Mount Piper to Wallerawang Transmission Line Upgrade Project

Submissions Report

December 2025

Figure 3.1 Access tracks that have been re-categorised – Map 1

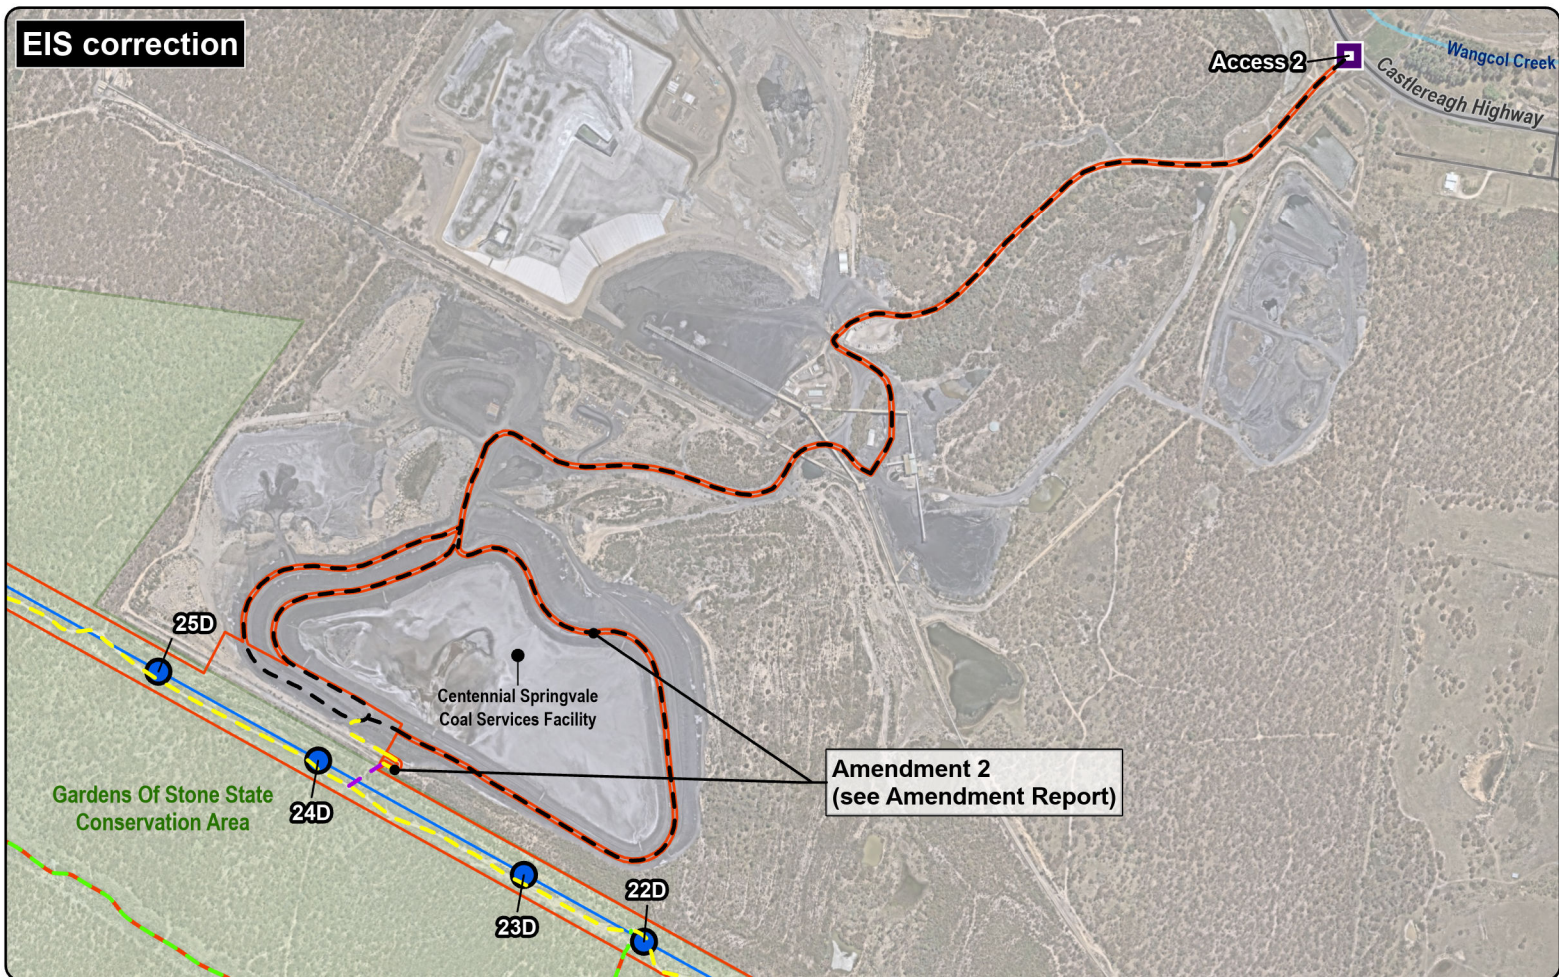
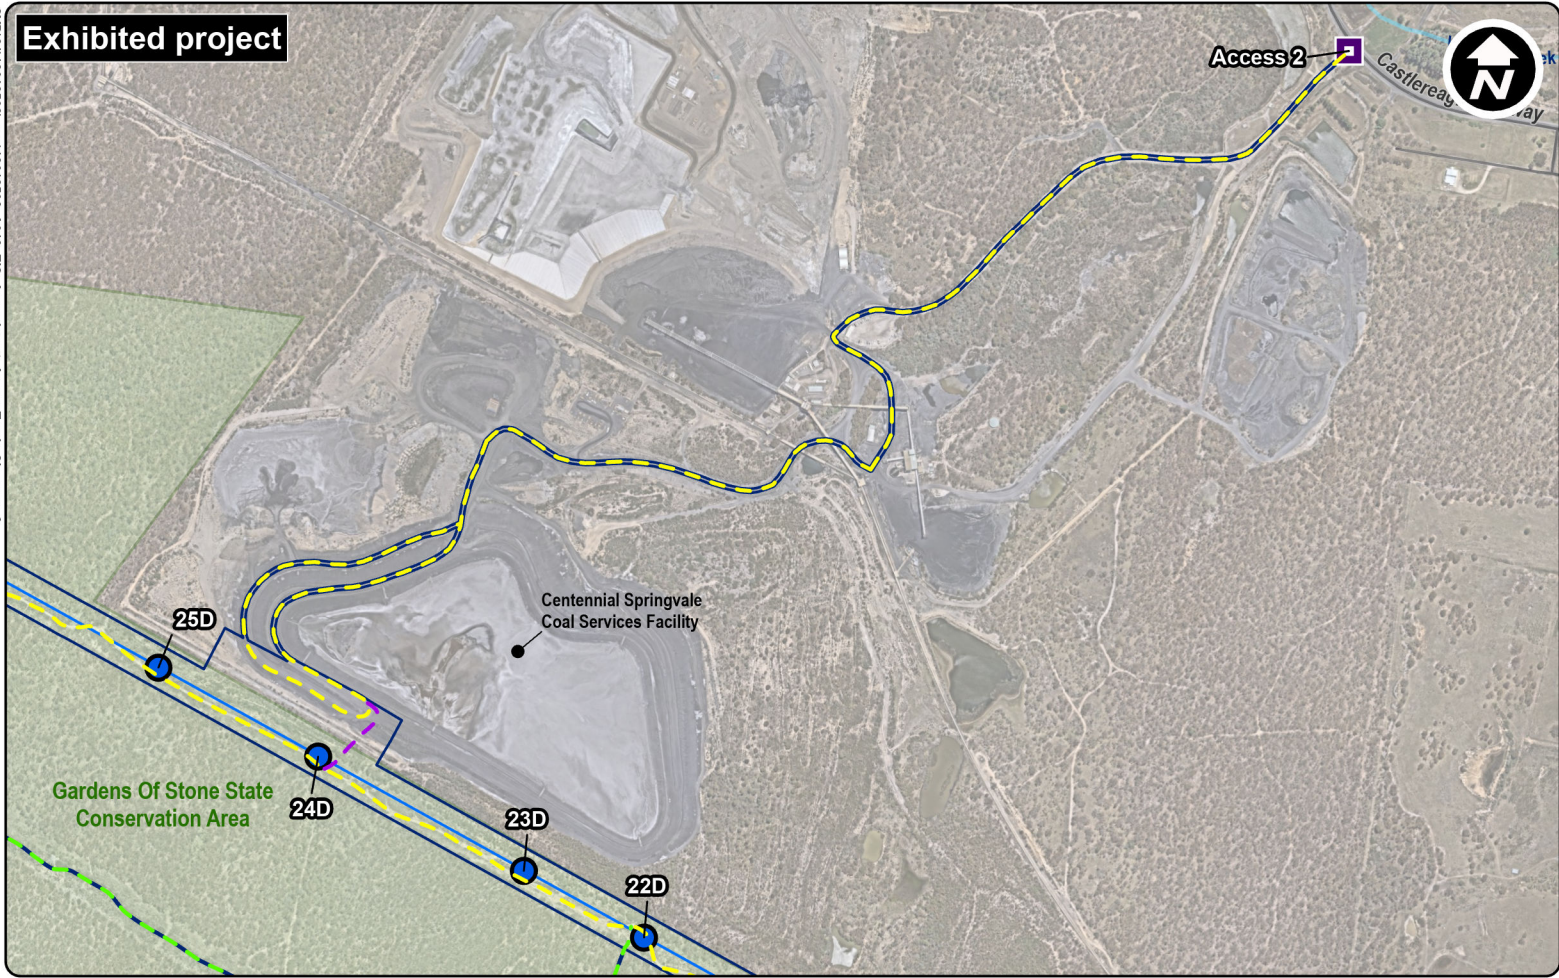
Since exhibition of the EIS, it was identified that some existing tracks were incorrectly identified as requiring upgrade and widening. This was mostly related to tracks located on properties owned by EnergyAustralia, Centennial Coal and on the former Wallerawang Power Station site. These tracks have been re-categorised and are shown in Figure 3.1 to Figure 3.4. The re-categorised tracks are also outlined in the Amendment Report (Transgrid, 2025a) and the revised project description (Appendix A of the Amendment Report).

Figure 5.1. Revised Figure 6-2 from ACHAR for pedestrian coverage – Map 1

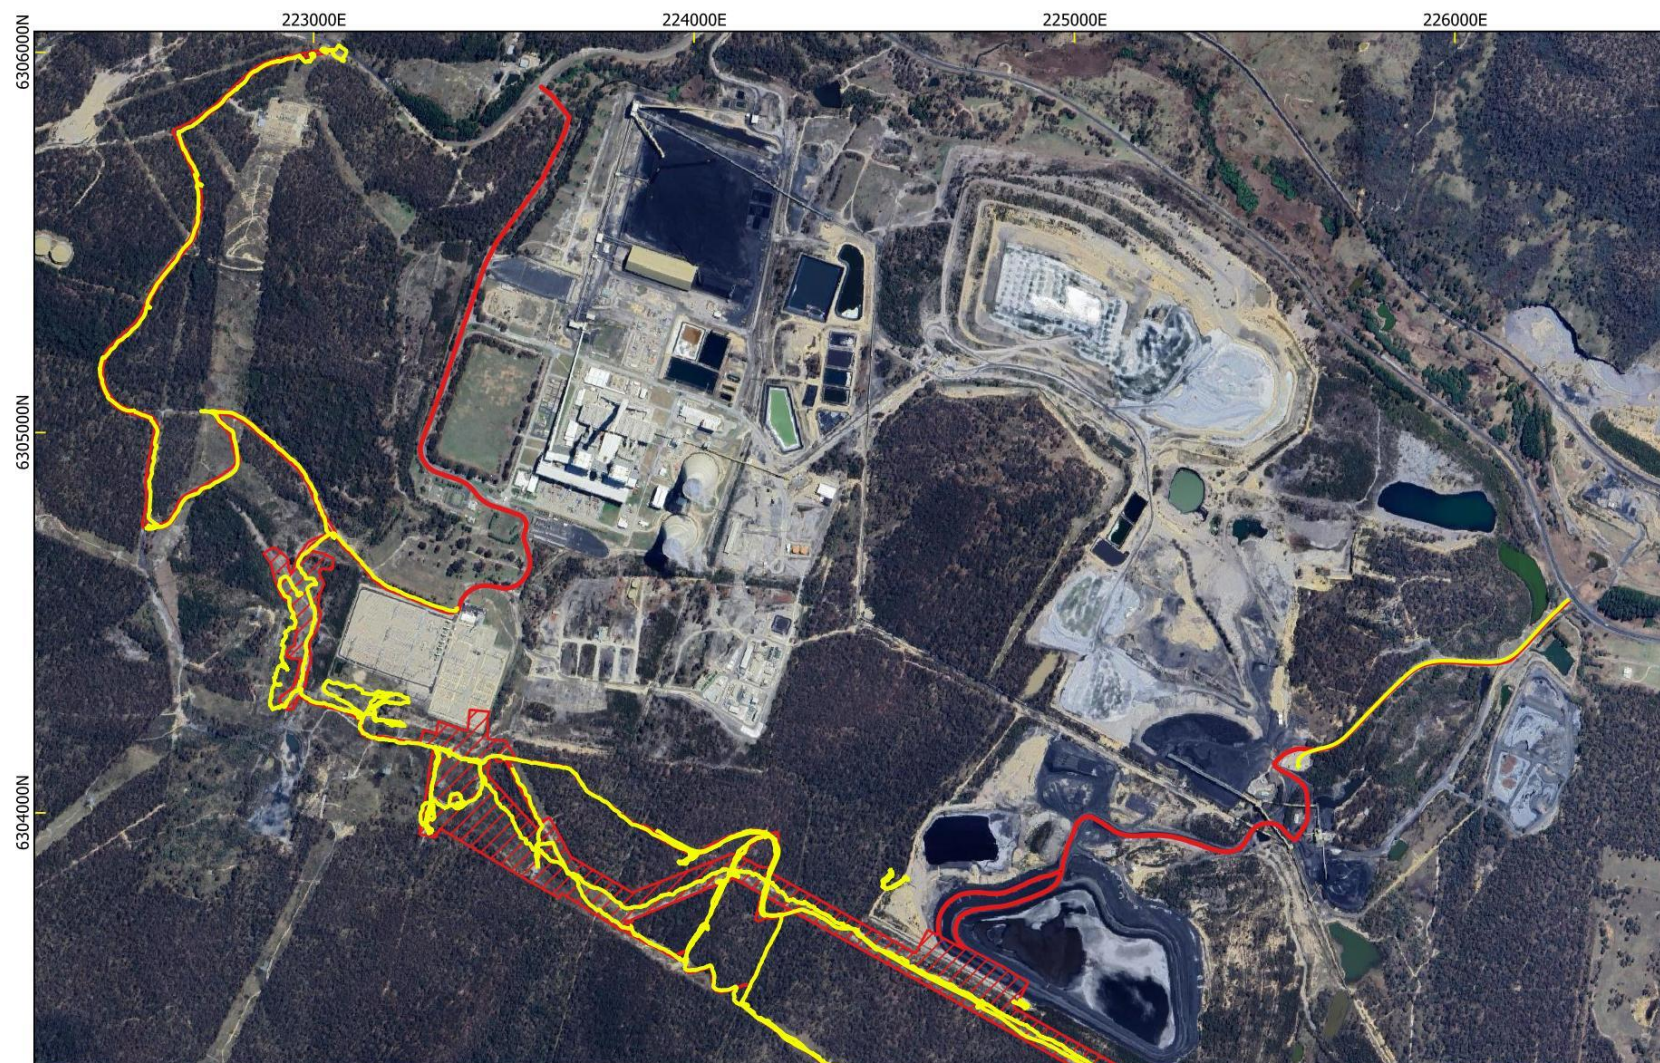
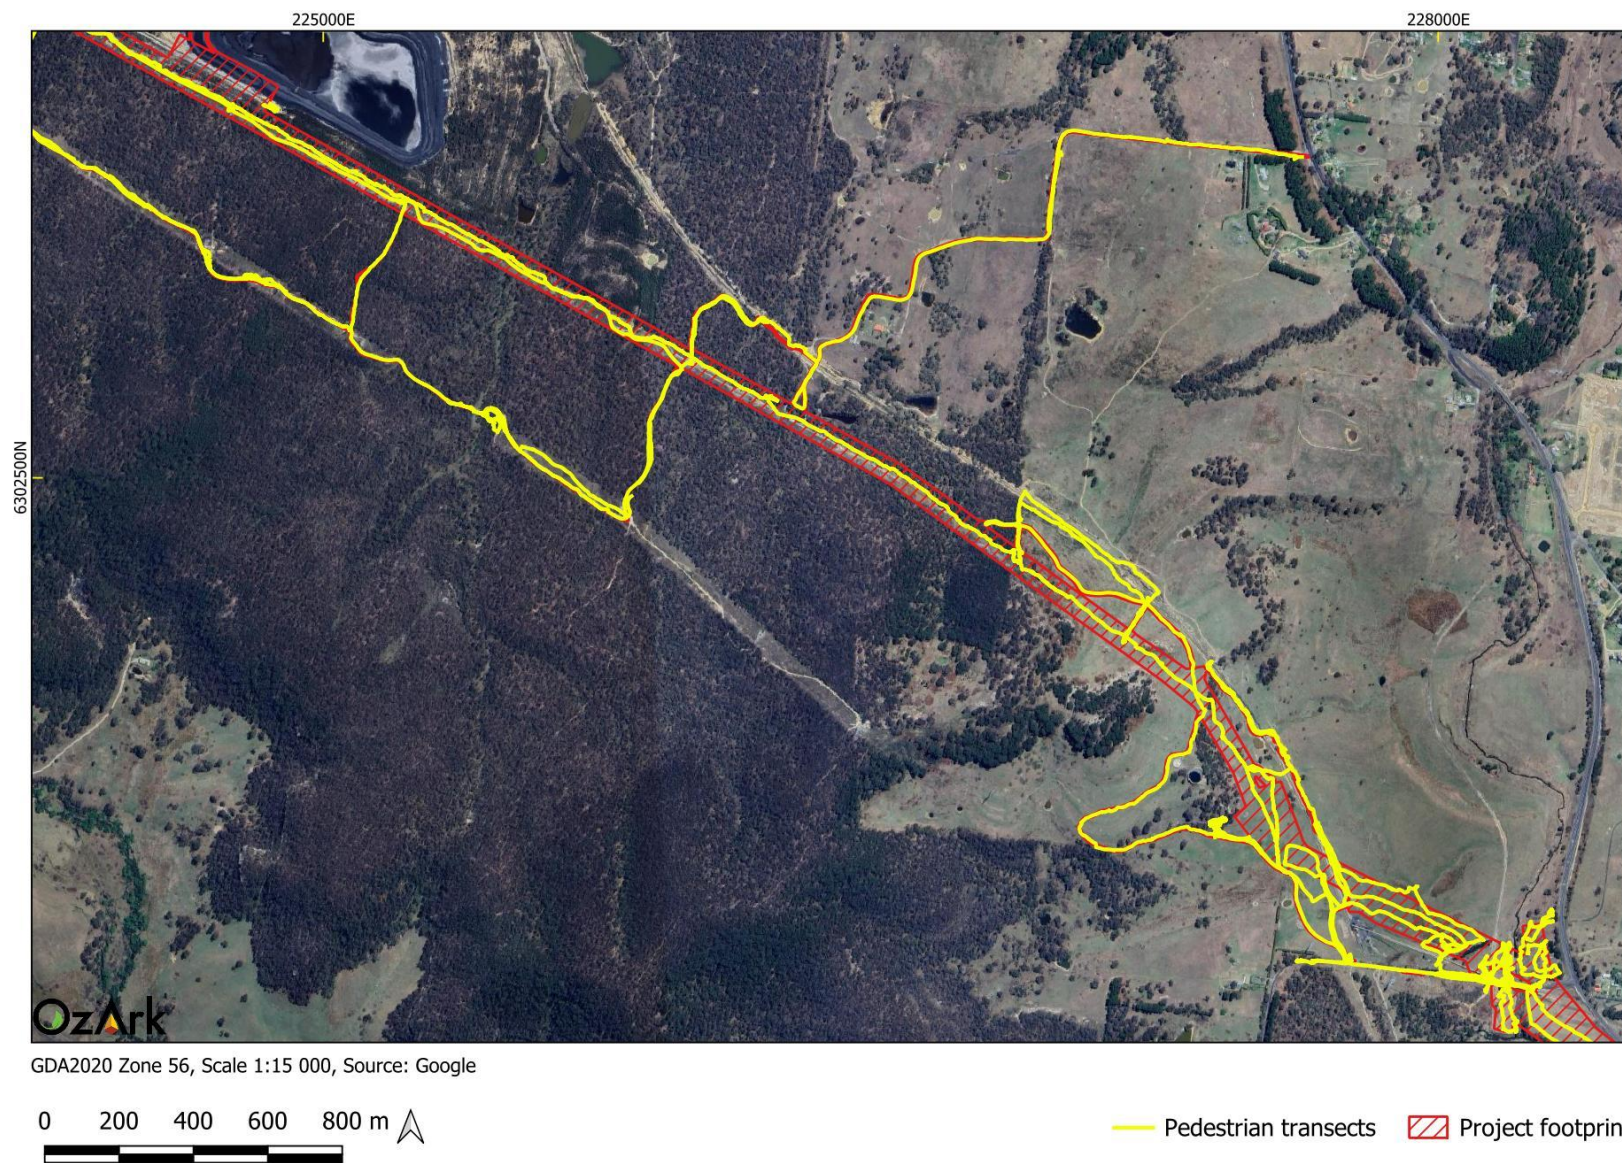
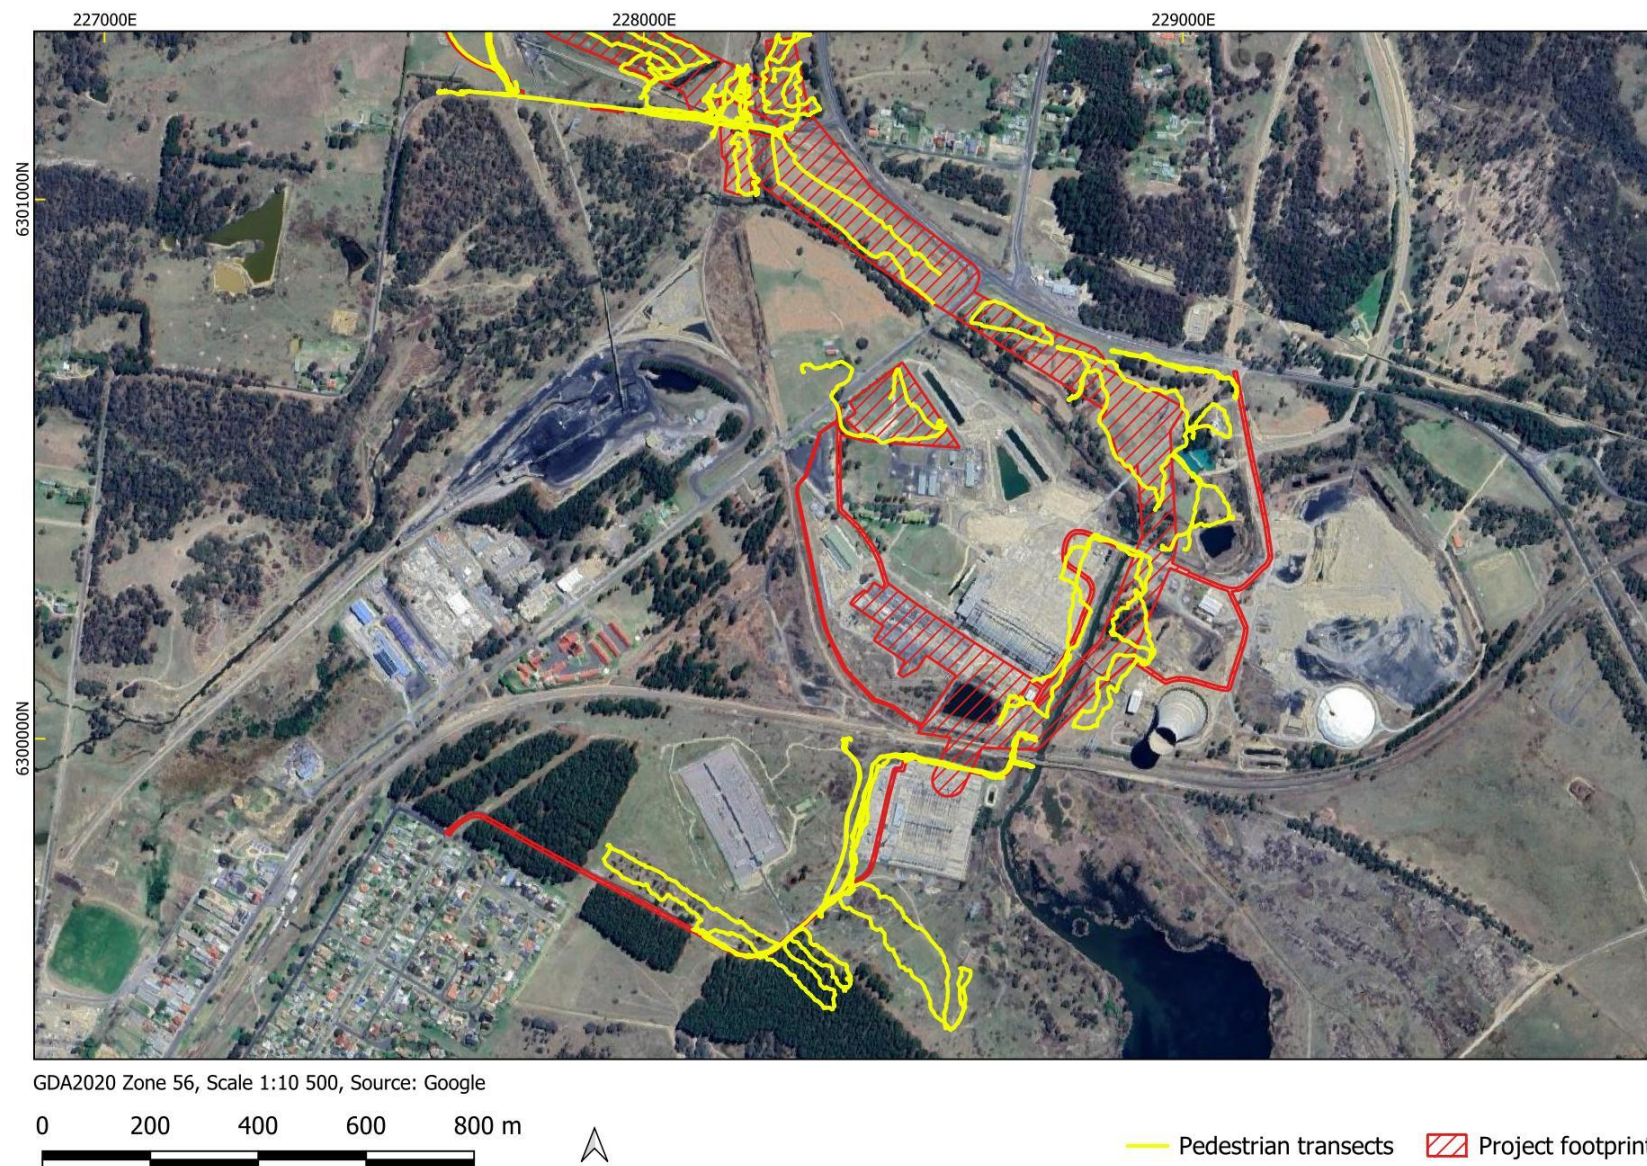
Please update the mapping provided in Figure 6-2 of the ACHAR to provide greater context to the track logs by reducing the mapping scale.	Mapping provided in Figure 6-2 of the Technical Report 5 – Aboriginal Cultural Heritage Assessment Report has been updated reducing scale to improve readability of the pedestrian coverage of the field survey. The updated figures are shown in Figure 5.1 to Figure 5.3 below.
Please clarify the number of test units excavated as a part of the excavation program. Section 7.4 states that 18 test units were excavated, but Figure 7-3 and Table 7-3 indicate that 17 test units were excavated.	A review has confirmed that 17 test units were excavated. Mention of 18 test units in section 7.4 is a typographic error.
